## Additional Information

### Item No.3

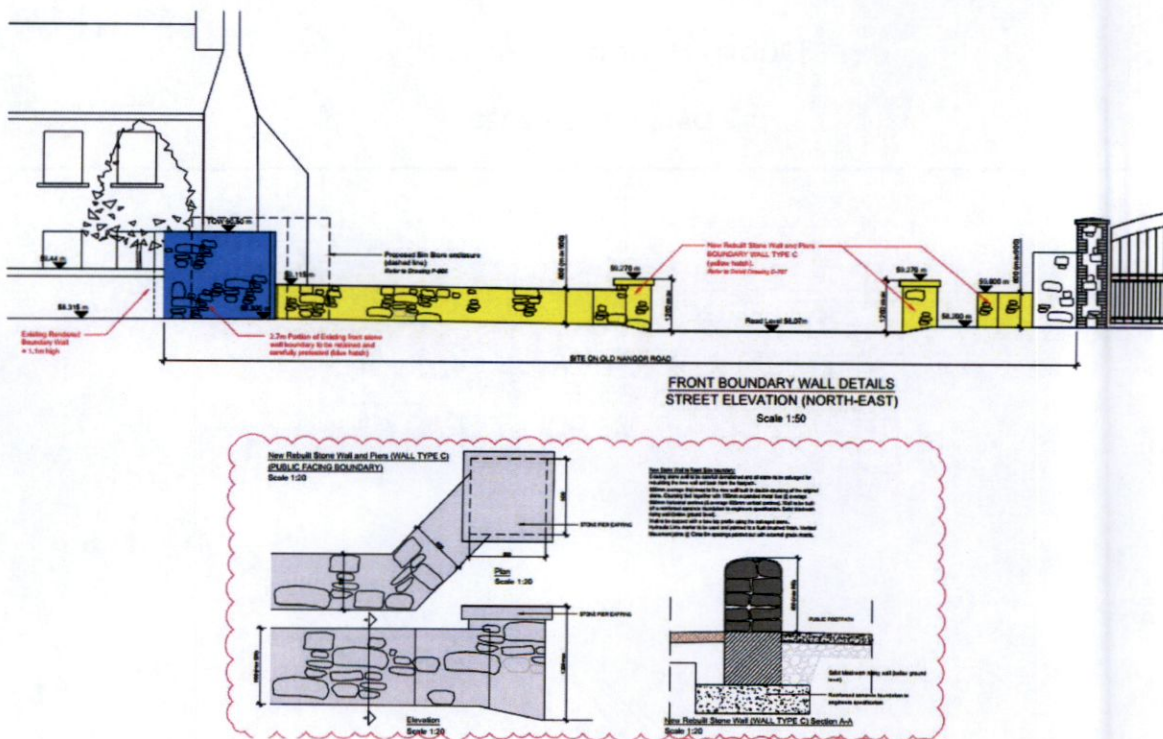
The applicant is requested to submit elevation drawings specifying the proposed boundary treatment to the front of the site.

Refer to Walsh Associates Drawings D-707 (Wall Type C) and D-708 (Street Elevation of rebuilt 800-900mm high wall), for revised boundary treatment to front of the site.

**FRONT BOUNDARY WALL DETAILS**  
**STREET ELEVATION (NORTH-EAST)**  
 Scale 1:50

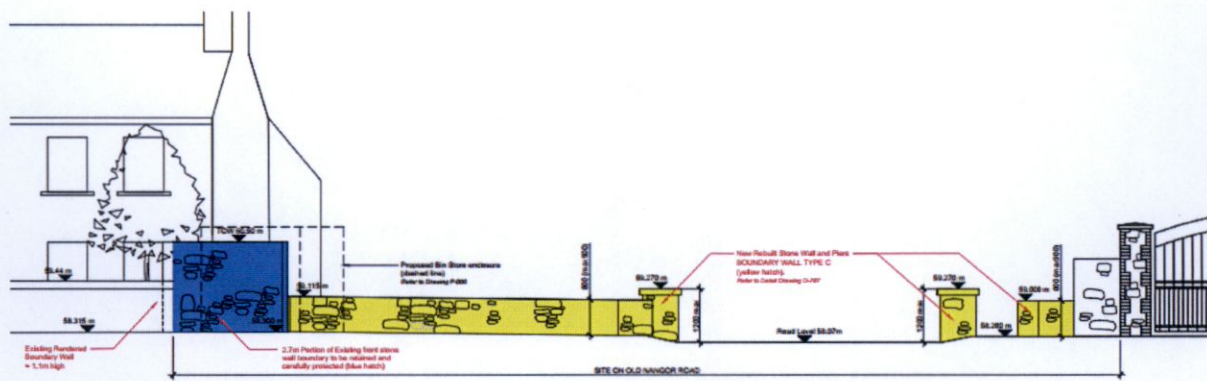
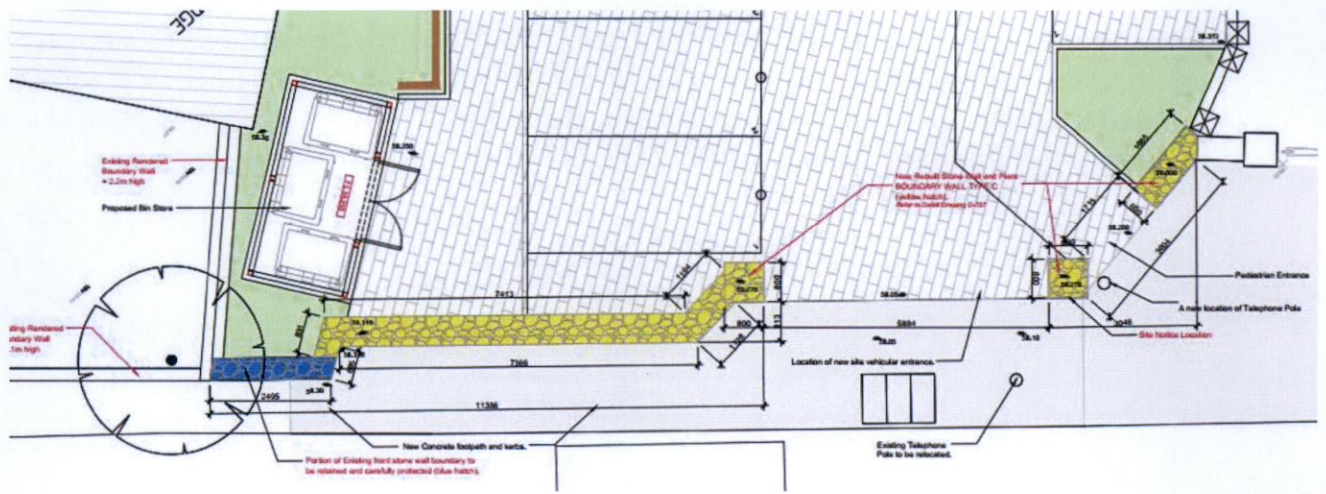
4.1. The applicant shall submit a revised layout of not less than 1:200 scale, showing boundary walls at vehicle access points limited to a maximum height of 0.9m, and any boundary pillars limited to a maximum height of 1.2m, in order to improve forward visibility for vehicles.

Refer to Walsh Associates Drawing D-708 (Plan & Elevation of rebuilt 900mm high wall illustrated at 1/50).

Refer to Walsh Associates Drawing P-002A enclosed for a revised overall site plan reflecting the revised front boundary wall arrangement illustrated at 1/100.

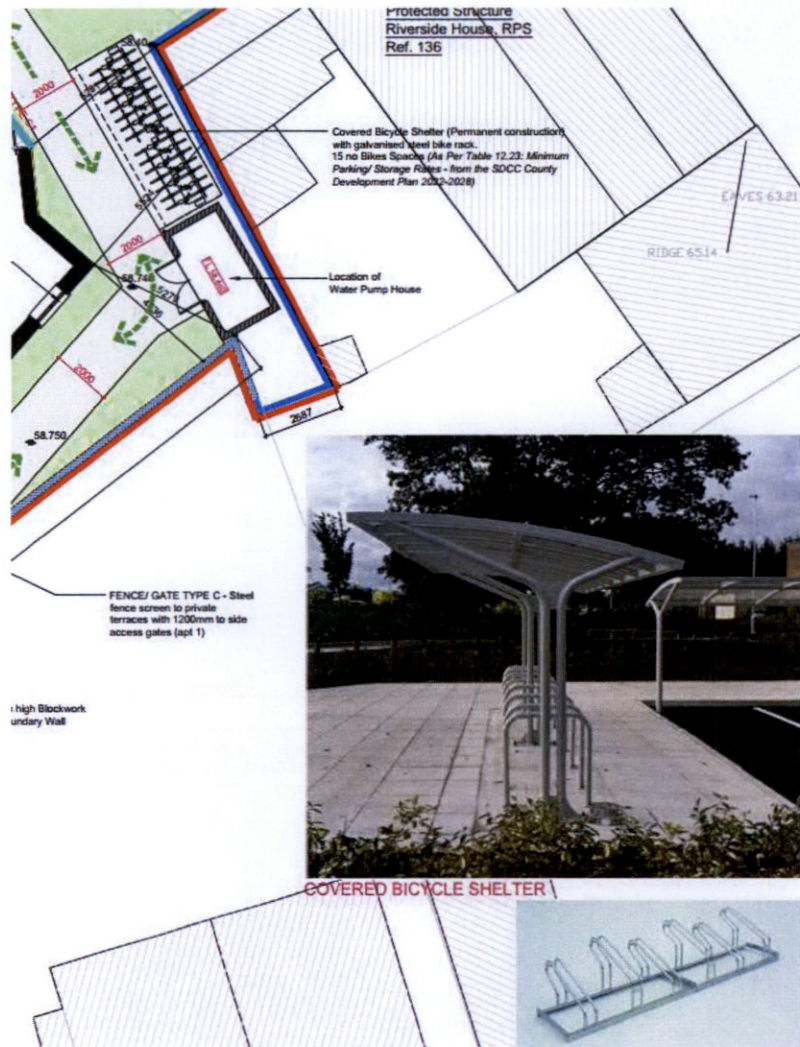
2. The applicant shall submit a revised layout of not less than 1:200 scale showing the location and number of Bicycle parking spaces to be provided at the development. Please refer to Table 12.23: Minimum Parking/Storage Rates – from the SDCC County Development Plan 2022-2028.

Refer to Walsh Associates revised Drawing P-002A (scale 1/100) for the location of a proposed covered bike parking area. The bike parking consists of a Galvanised steel rack with a Proprietary Galvanised steel frame & polycarbonate shelter as below. 15no. parking spaces in accordance with the SDCC County Development plan for 10no. Apartments.

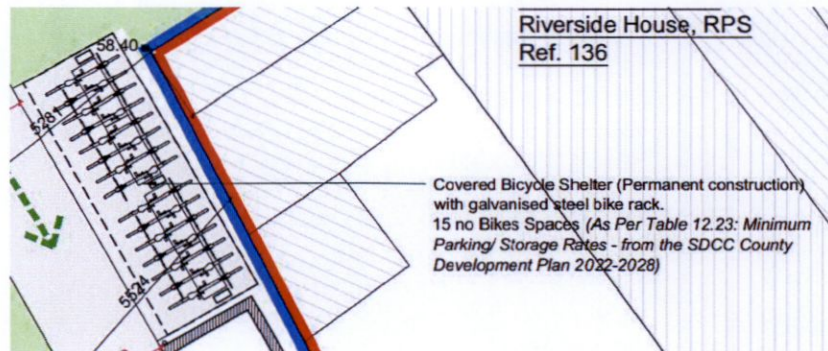
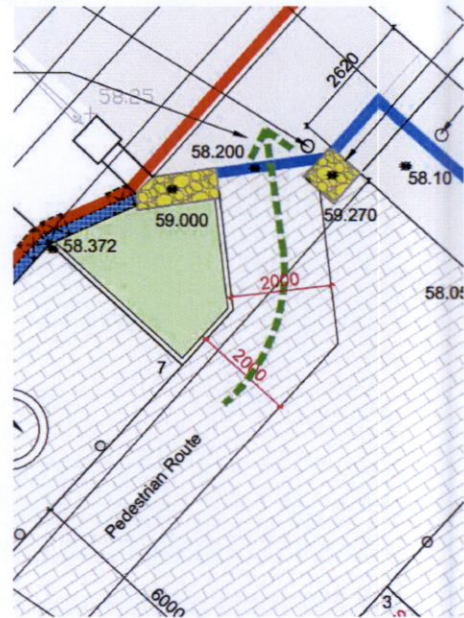
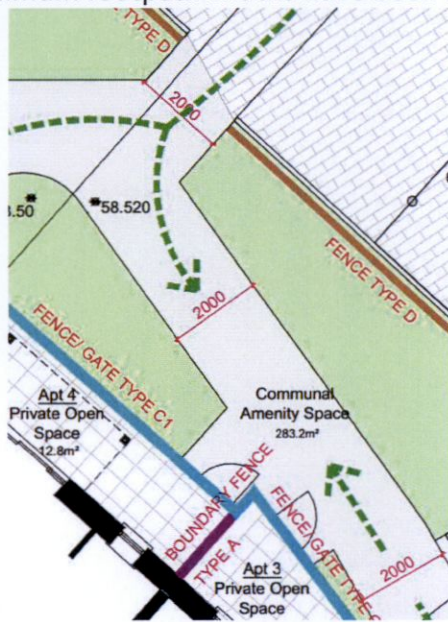
4. The applicant is requested to submit a revised layout not less than 1:200 scale showing the car parking, bicycle parking and pedestrian routes within the development. Please refer to Table 12.23 Minimum Bicycle Parking Rates– SDCC County Development Plan 2022-2028.
- The minimum width of footpaths shall be 2.0m wide to aid mobility impaired users.
  - All external bicycle parking spaces shall be covered.
  - Footpath layout shall provide adequate connectivity around the development and to footpaths on the main road.

Refer to Walsh Associates revised Drawing P-002A for the location of proposed carparking , covered bike parking (15no. in accordance with Table 12.23) and pedestrian routes. Minimum footpath widths have been revised to 2.0m wide.

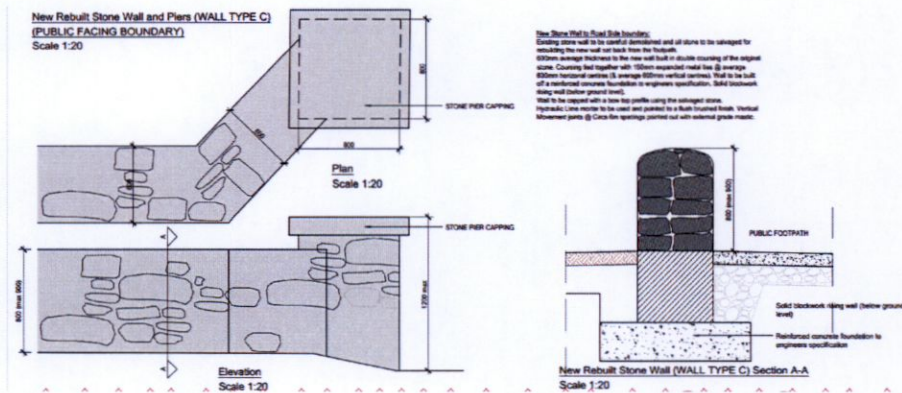
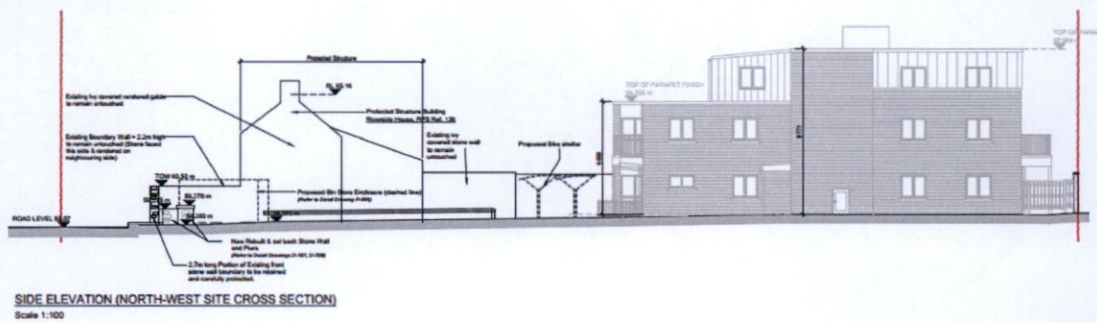
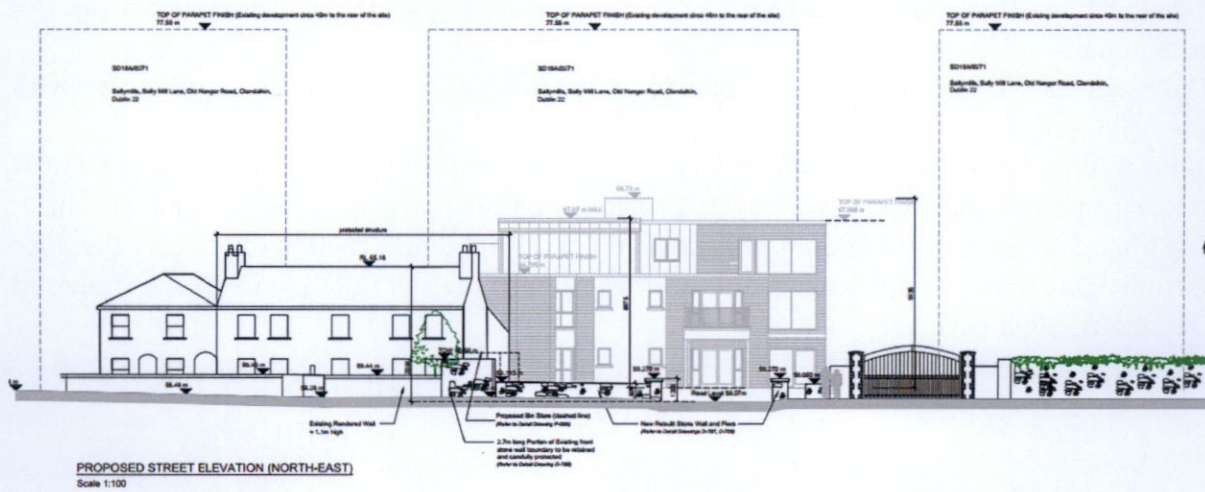
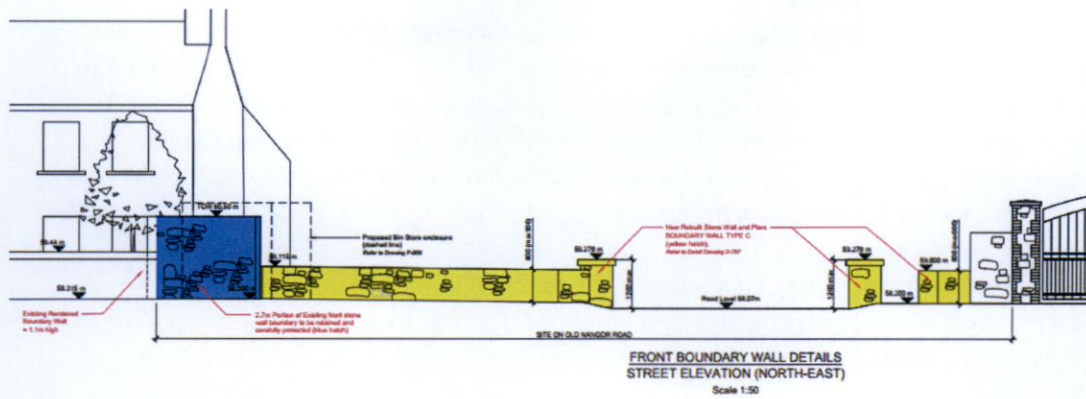
The drawings submitted regarding the boundary of the site need more detail regarding the existing retained and proposed built front boundary wall for a full assessment. The Planning Authority considers that the applicant must demonstrate further that the proposed development will not adversely impact the nearby Architectural Conservation Area. (i) The applicant shall submit a revised detail of the works involved in the boundary wall and include colour hatching of the proposed and retained elements; in contiguous and sectional drawings

The Project Architects have taken full account of the site setting and the adjoining protected structure: the former RIC Barracks (South Dublin County Council RPS Ref. 136). Furthermore the Project Architects are aware that the former RIC Barracks is subject to an objective in the South Dublin County Development Plan 2022 – 2028 that seeks “to investigate the purchase and development of the old RIC Barracks on the Old Nangor Road which is a Protected Structure within the present Architectural Conservation Area”.

The proposed development site is a brownfield area, formerly associated with the site of the former Sallypark House. The front boundary wall is the only extant feature of any historic character within the subject site. The proposed development will not negatively impact the setting of the former RIC Barracks and will not impede the Planning Authority’s desire and objective to bring about the restoration of the protected structure. While the proposed development site is not located within the Clondalkin Architectural Conservation Area (ACA) it does abut it: the ACA does include the former RIC barracks. The proposed new buildings are set back from the road and do not impact on the architectural conservation area or the protected structure. Whilst the new housing units will be taller than the former RIC barracks, there are consistent with buildings in the wider vicinity and moderate between the height of the RIC at street frontage and the taller existing apartment scheme which is located to the rear of the proposed development permitted under Planning Register Reference SD18A/0271 & SD22A/0038. From an Architectural heritage perspective, the development is a proportionate and sympathetic intervention.

Refer to Walsh Associates Drawing D-709 enclosed for proposed contextual street elevation and site section.

It is proposed to carefully take down and store the rubble masonry that makes up the roadside boundary wall to the subject site. A new wall, set back slightly from the street, will be built by suitably experienced contractors; the new wall will incorporate and re-use the harvested rubble masonry. The applicant invites a planning condition that stipulates this requirement/intervention. Refer to Walsh Associates Drawings D-707 and D-708 enclosed for further detail on the boundary treatments to front stone wall of the site.

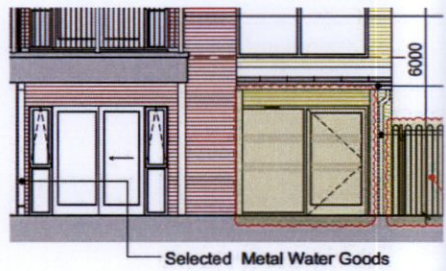
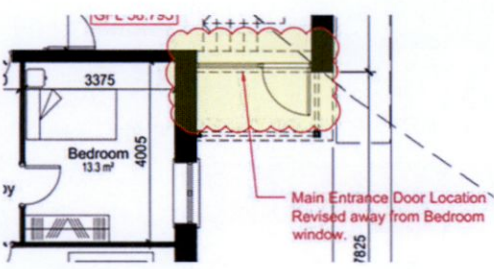
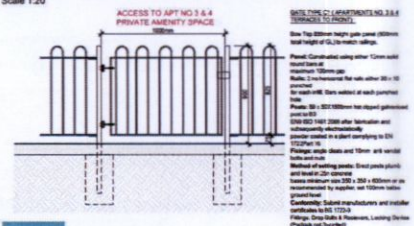
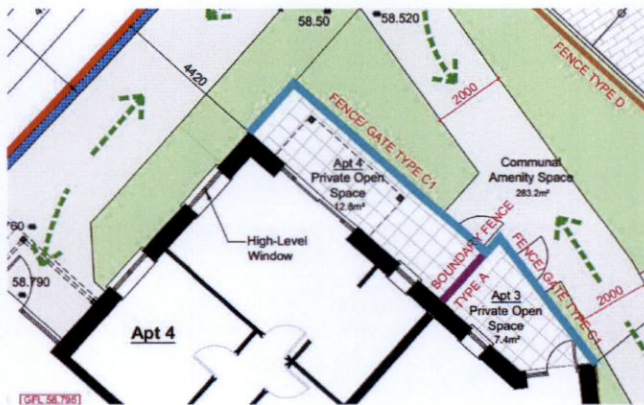
There are concerns with the layout of the proposed development regarding the private amenity space of the future occupiers of ground floor apartments 3 and 4. The area of private space appears to be open and contributes to communal open space given its shape and use as circulation space. The proposed development boundary treatment and/or 'privacy strip' should be revised to provide distinctly private and usable communal open space in accordance with the Sustainable Urban Housing: Design Standards for New Apartments (2020) and South Dublin County Development Plan 2022-2028.

(a) revised section and elevational drawings that illustrate that a sufficient level of privacy is afforded to the habitable rooms of ground floor apartments 3 and 4, including the bedrooms.

Refer to Walsh Associates Drawing P-002A site plan and D-708 Boundary Details drawing enclosed for clear demonstration of proposed railings & own private gate forming the individual apartment private external spaces and providing a physical separation from the communal amenity space.

Refer to Walsh Associates Drawing P-005 revising the Apartment 4 living room window (NW side elevation) to a high level window to provide additional privacy to this habitable room.

The Main Building Entrance door to NE elevation of the building is revised to relocate the door further away from the Apt 4 bedroom window, refer to revised floor plan P-003 and revised Elevations P-005 enclosed.
